TACKLE BOX

RESTAURANT RENOVATION AND DECK ADDITION

Planning Review Board
Revision

Pages now labeled Approved or Revised
with short description. Narritive Attached

**Proposed
Rendering
Item #26.2**

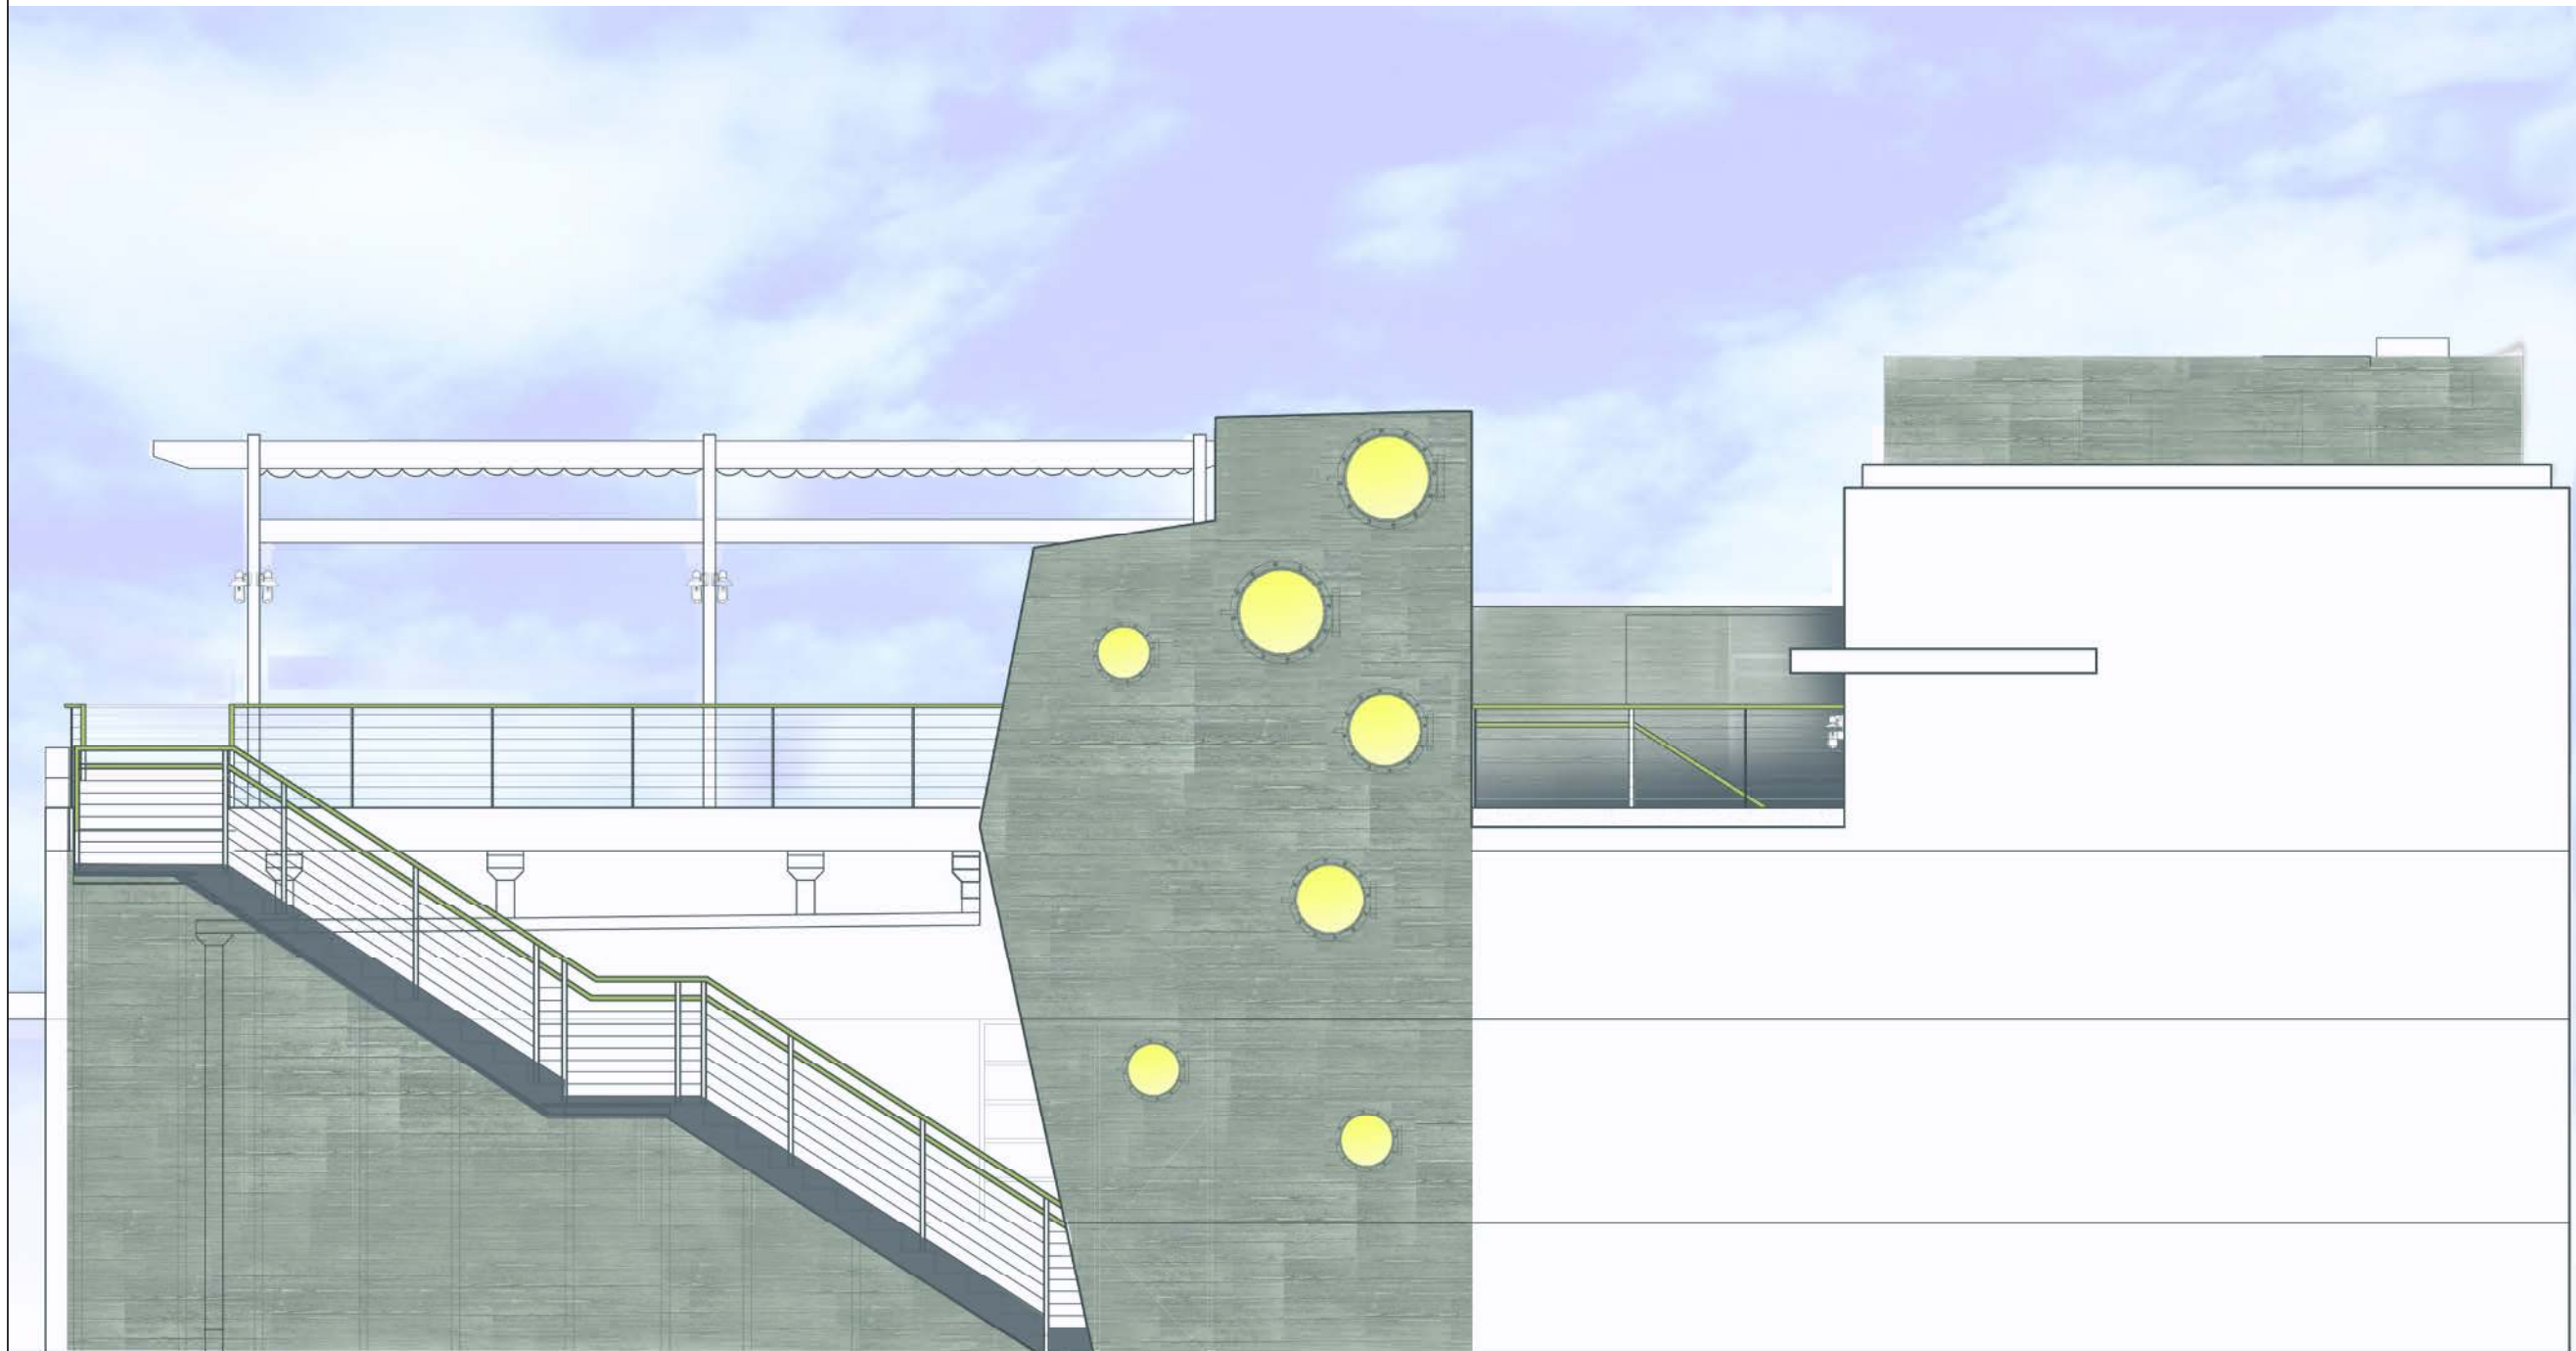
**PROPOSED
NEW STAIR ORIENTATION AND MECHANICAL ROOM ON
ELEVATOR SHAFT**
